In the Matter of)
)
Advanced Television Systems)
and Their Impact Upon the) MM Docket No. 87-268
Existing Television Broadcast)
Service)

PETITION FOR RECONSIDERATION AND CLARIFICATION

Engineering Statement of Hammett & Edison, Inc.

TV Station KPDX • Channel 49 • Vancouver, Washington

Grade B Coverage Contours
DTV Allotment Method vs. Section 73.684 Method
3,160 kilowatts (DA), 616 meters AMSL

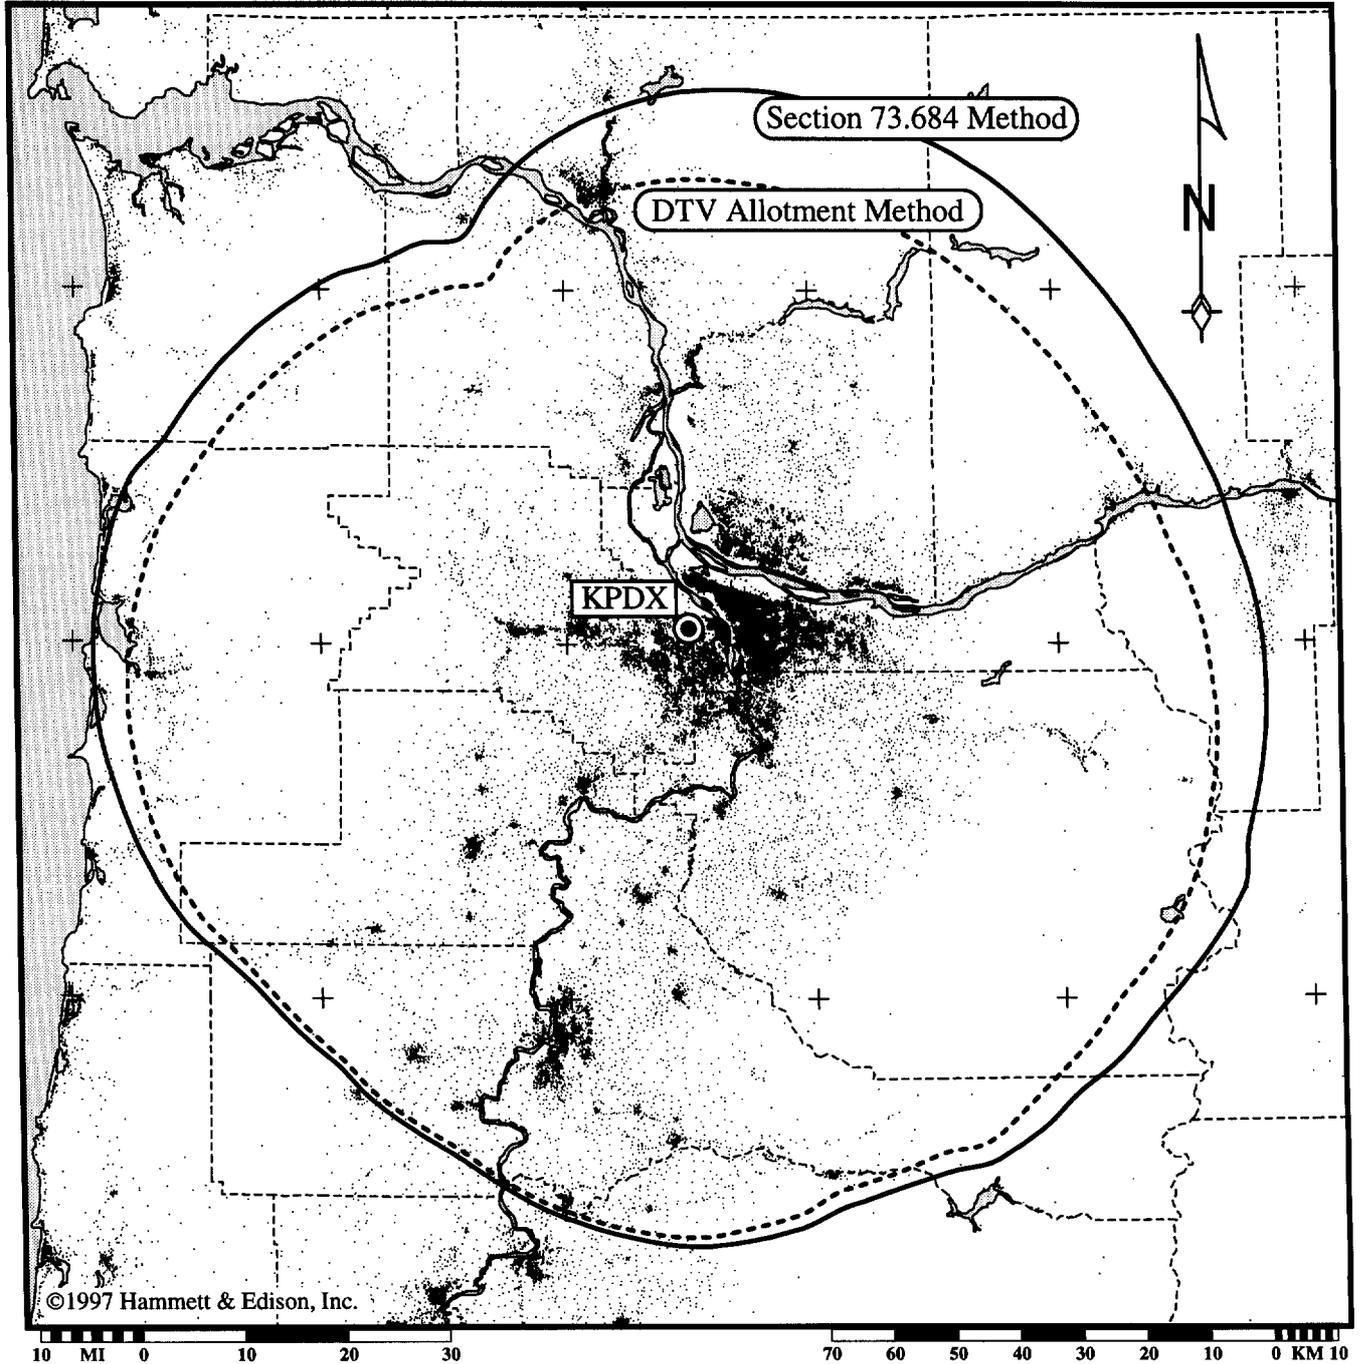
In developing a protected coverage area for allotted DTV facilities, the Commission used the horizontal-plane antenna patterns contained in its engineering database. Use of these patterns can in many instances lead to incorrect projection of the Grade B contour. Hence, the DTV directional antenna (DA) pattern, ERP, population, and area calculations would all be in error. All of these errors tend to penalize the station being analyzed, since the horizontal-plane antenna pattern is usually smaller than the main-beam antenna pattern (and, in any case, cannot be larger). Figure 1 shows Grade B contours for KPDX projected using both the method contained in the Commission's DTV software and the method specified in Section 73.684 of the Commission's Rules. There is a 12.1% difference in coverage area and a 2.0% difference in coverage population between the two methods, due in large part to the Commission's failure to account for the actual elevation pattern of the KPDX antenna, including the use of mechanical beam tilt.

Cells Within Grade B Contour
Where Longley-Rice Algorithm Returned an Error
and was Unable to Calculate Path Loss

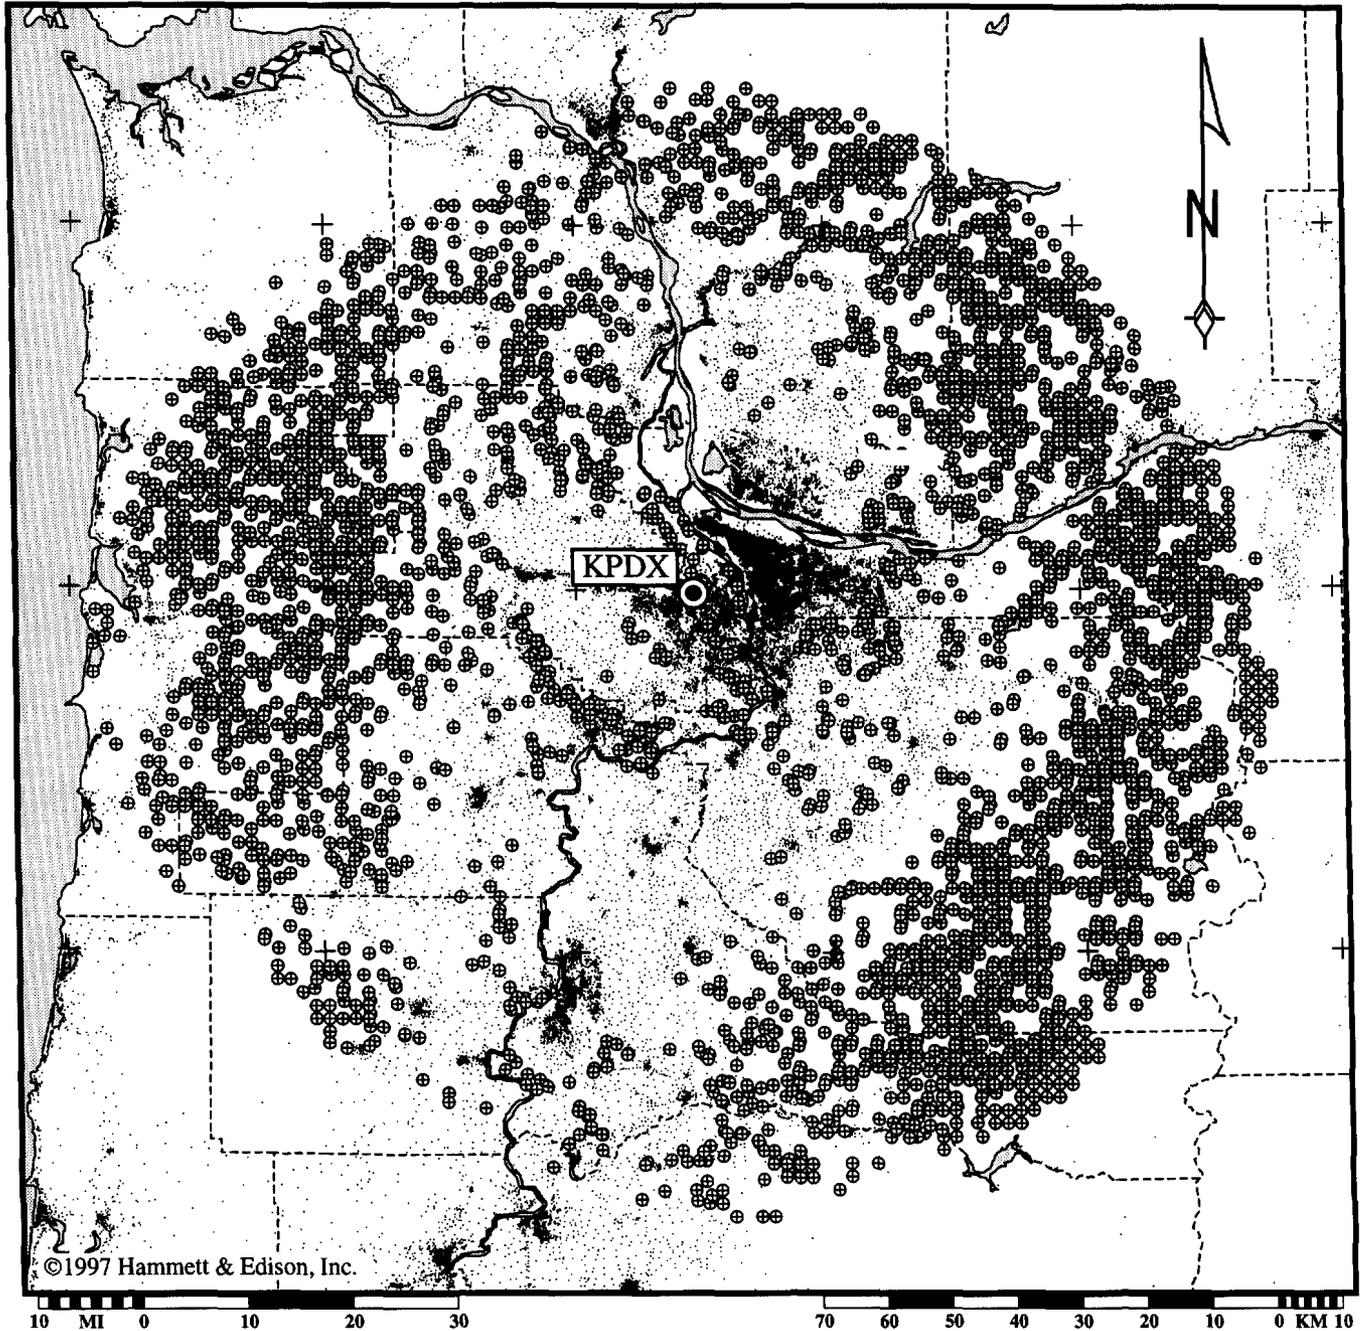
itself is not always capable of determining, within certain confidence limits, whether a particular cell has service. Specifically, in cases where the actual horizon from a given cell or transmitter location is less than 0.1 times or greater than 3 times the distance to the smooth earth horizon, the Longley-Rice algorithm will return an “Error Code 3” that, according to the program documentation, means internal program calculations show parameters out of range, and any reported results are dubious or unusable.

The procedure used by the FCC when such a Longley-Rice error occurs, when determining whether a cell has service or when determining potential interference to a cell, is to mark that cell as “interference-free service” and it is not considered further. While this assumption appears not to introduce significant overall errors in areas of relatively flat terrain, it has been found that the error code is returned much more often for studies involving mountainous terrain between studied transmitter sites and cells.

Figure 2 shows the locations of cells within the assumed KPDX Grade B coverage area where the Commission has assumed coverage, even though the Longley-Rice algorithm has determined that its result may be in error. 6,151 square kilometers (27.6%) of the assumed Grade B land area and 84,054 persons (4.5%) of the assumed Grade B population lie in cells where Longley-Rice returned errors, indicating that the actual coverage (both NTSC and DTV) could be significantly in error. Clearly, the Longley-Rice propagation algorithm is unsuitable for determining accurate interference profiles of areas affected by mountainous terrain.
